Rezoning Transportation Analysis

Petition Number: 2016-112

General Location Identifier: 07111401, 07111402, 07111403...

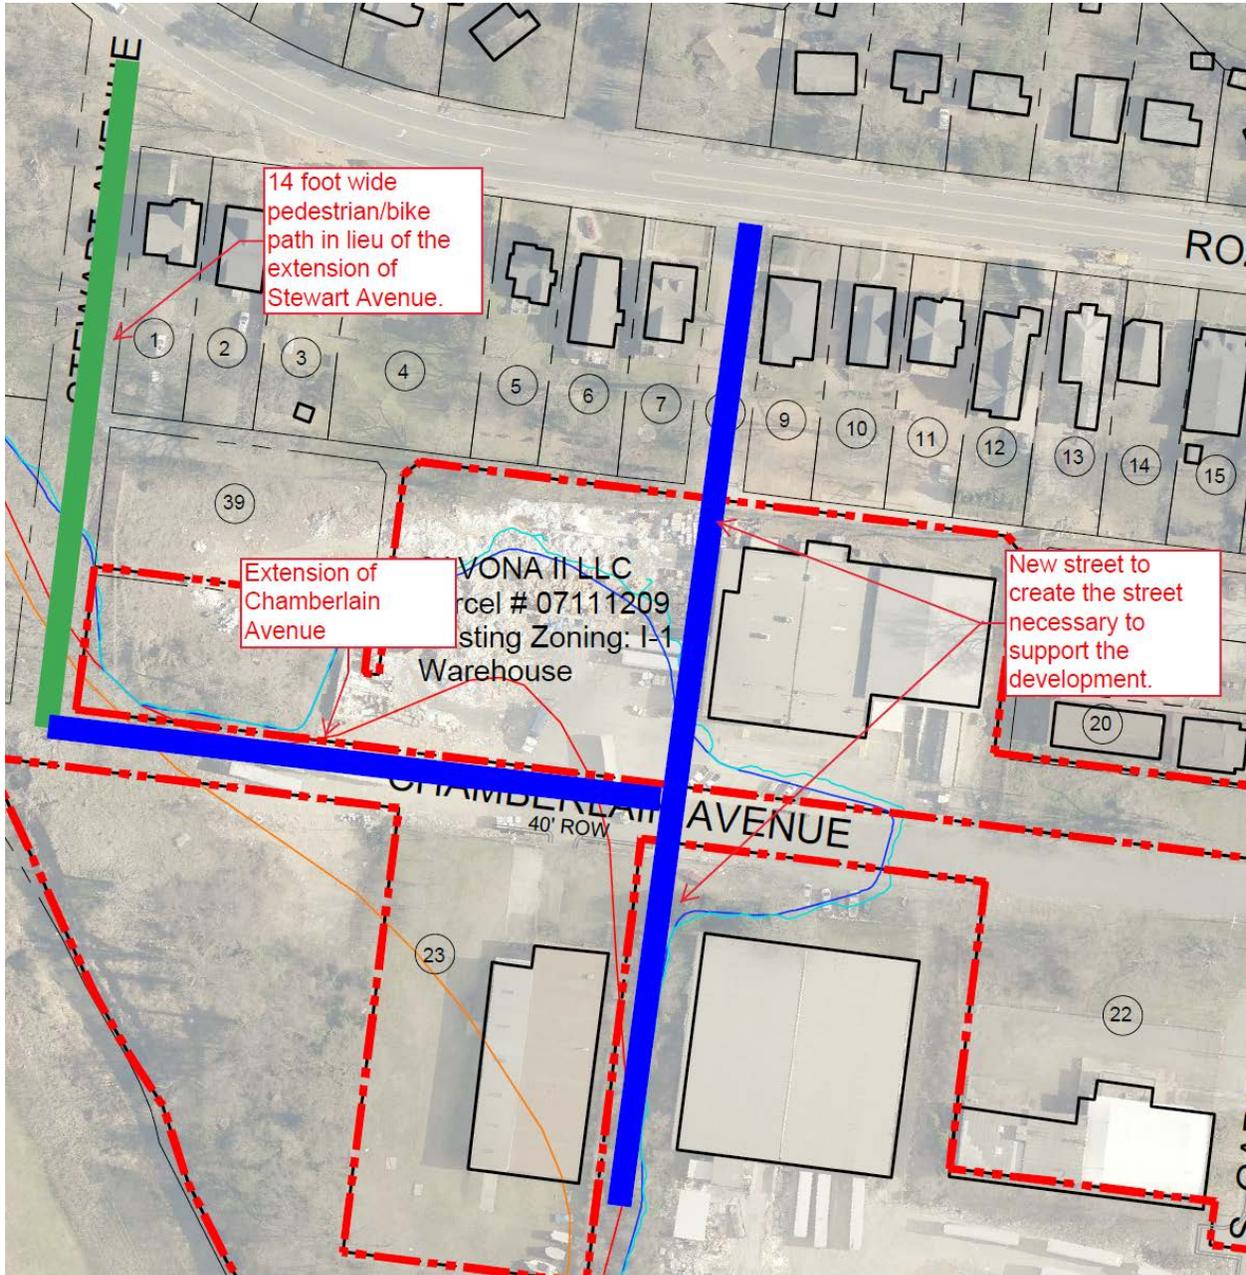
6. The petitioner should revise the site plan to show the extension of Stewart Avenue from Rozzelles Ferry Road to Chamberlain Avenue.
 - a. The current site plan increases the vehicular trips generated which creates a greater need for improvement to the existing street network. In its current form the site plan proposes development on the block of Chamberlain Avenue between South Gardener Avenue and future Stewart Avenue that exceeds 800 feet. This type of block length and lack of road network is not in line with the maximum block lengths of 650 feet envisioned by the City for mixed use developments located in a wedge. If the extension of Stewart Avenue is not achievable due to site conditions, a pedestrian/bike connection can be built in its place and a north-south street connecting Rozzelles Ferry Road to Chamberlain Avenue and into the site can be built in the location shown below:
